ANN ARBOR HISTORIC DISTRICT COMMISSION

Staff Report

ADDRESS: 418 S First Street, Application Number HDC11-091

APPLICATION: The applicant seeks HDC approval to demolish a one-story garage and construct a two story tandem garage with a studio above.

Topographic map with building footprints (footprints are taken from aerials and are not necessarily to scale)

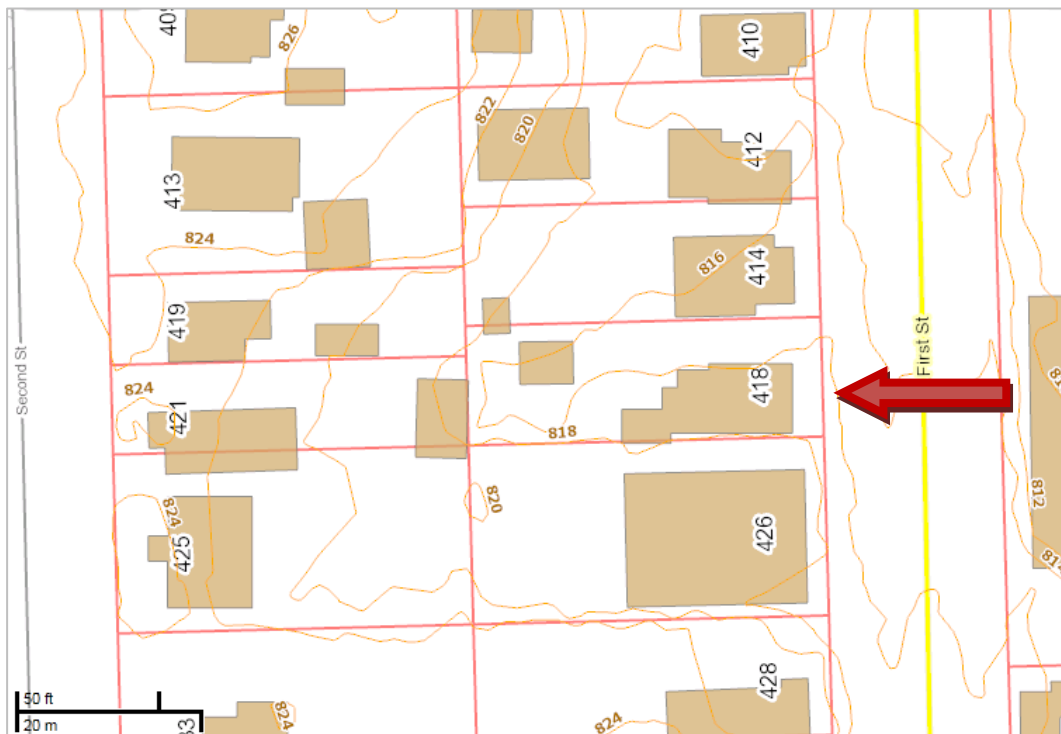
2. This house is situated in a low spot on this block. The houses behind it on Second Street are on ground 8' higher at their front elevations (see topo at end of this report). Surrounding buildings of interest include a large modern apartment building to the south with an entirely paved backyard, a 1 ½ story building near the west (rear) property line that is similar in height to the one proposed in this application, and a large one-story cinderblock building in the backyard two lots to the north that is home to a plumbing and heating company (see area plan submitted with application and aerial photo). Another site consideration is that there are no houses across First Street, only a large lumberyard building that presents a blank wall parallel to the street.

AREA PLAN AND SITE SECTION
PROPOSED GARAGE / STUDIO
 418 SOUTH 1ST STREET ANN ARBOR, MICHIGAN 48103
 ANN ARBOR HISTORIC DISTRICT COMMISSION APPLICATION

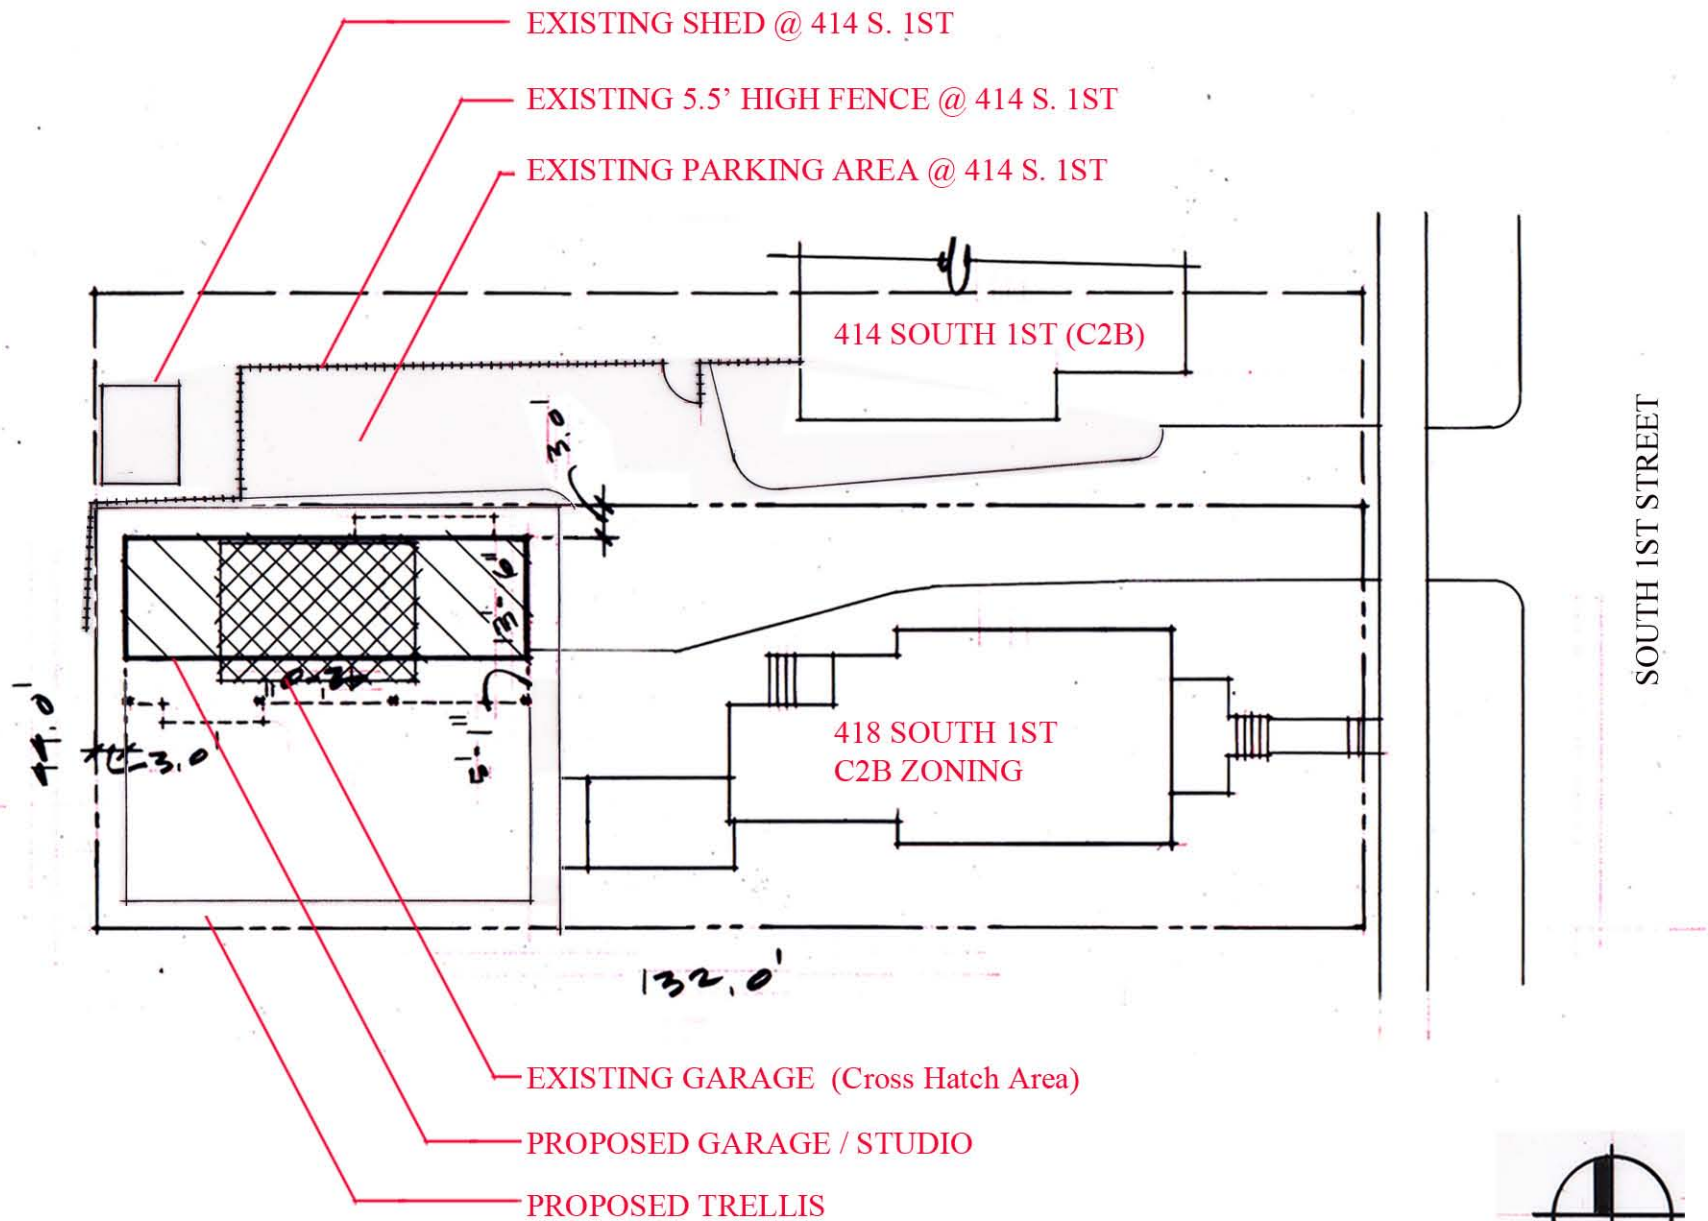
1. Changes to this application from the one denied last month include (see application for additional explanation from applicant):
 - a. Dormers now have a traditional shed roof to address concerns of commissioners.
 - b. The trellis structure has been expanded to define a rear courtyard area in the backyard. This particular yard is already substantially walled off by fences and buildings located on neighboring properties, thus the trellis will have no negative impact on the neighborhood or district. It is also designed to be reversible.
 - c. A site section drawing comparing this building to neighboring ones is now included on the top of the Area Plan sheet.
